1.3 MONASH BOULEVARDS – FEEDBACK FROM STAGE 2 CONSULTATION AND ADOPTION OF UDF

The purpose of this report is to consider the feedback received following the community consultation undertaken for the Draft Monash Boulevards Urban Design Framework (BUDF), to consider the proposed revisions to the BUDF in response to the community engagement and to consider adopting the revised BUDF.

Figure 21. DR-04 Dandenong Precinct Plan 4

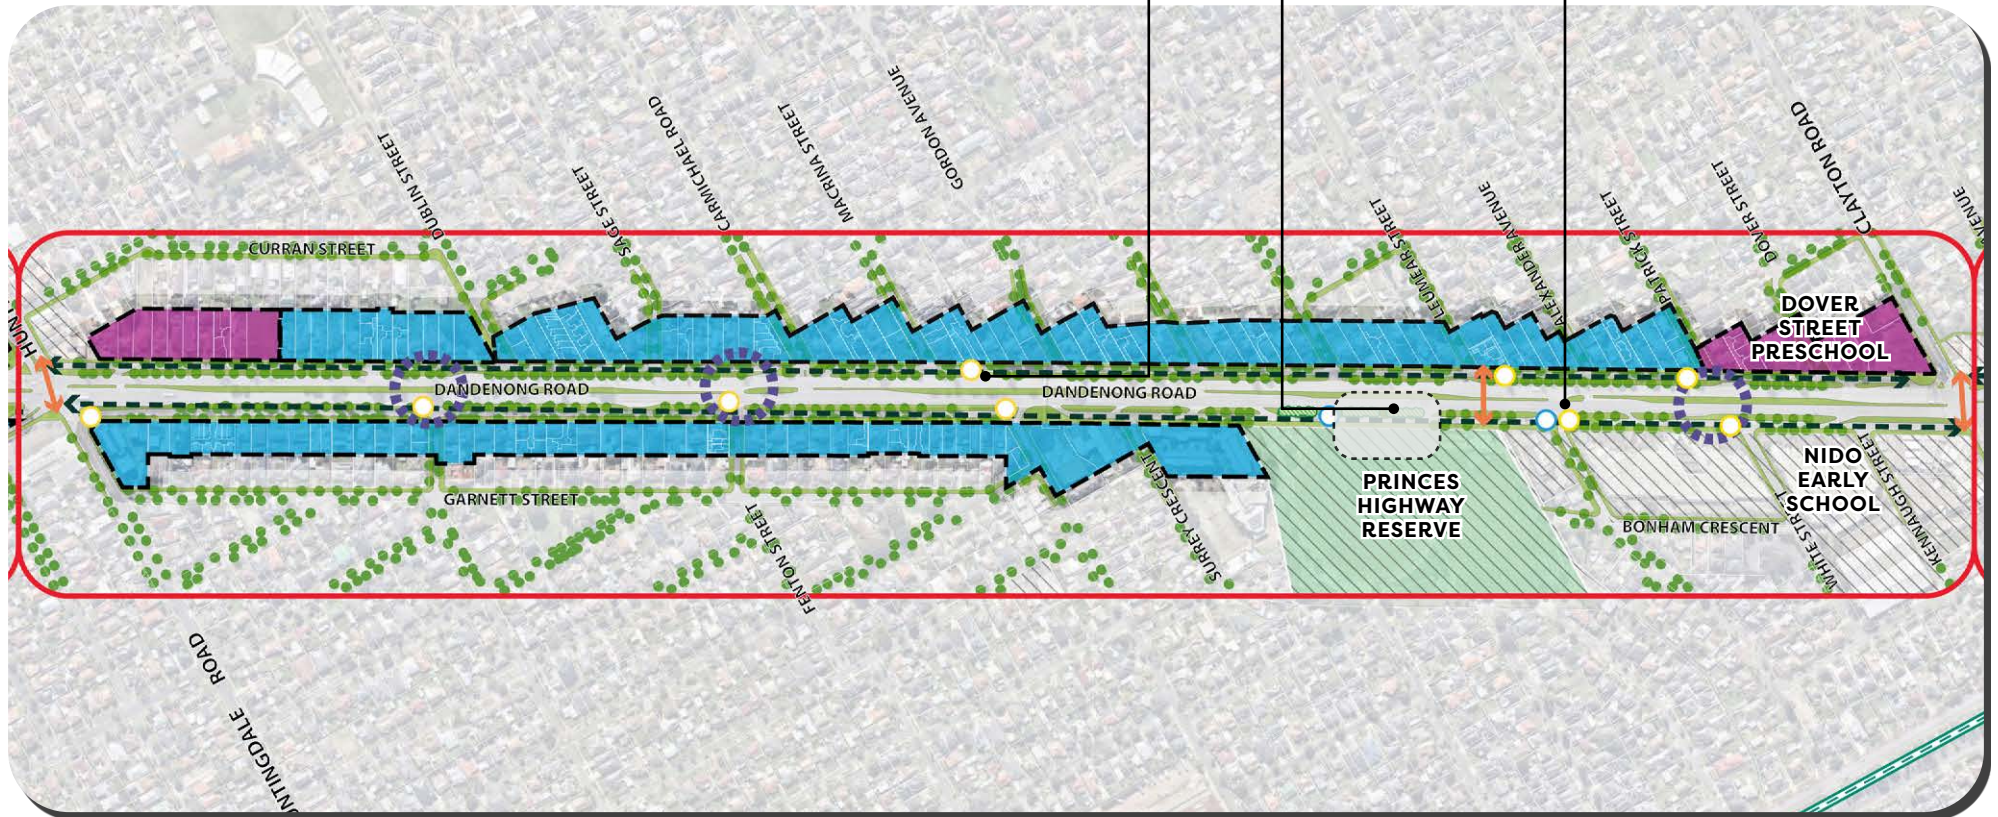
- Reduce the extent of 6 storey area in in DR4, north side of Dandenong Road, by moving the boundary from Dublin Street, west to the boundary between 1737 and 1739 Dandenong Road, Oakliegh East.
- See map below. The blue section identifies the revised proposed 4 storey maximum areas.
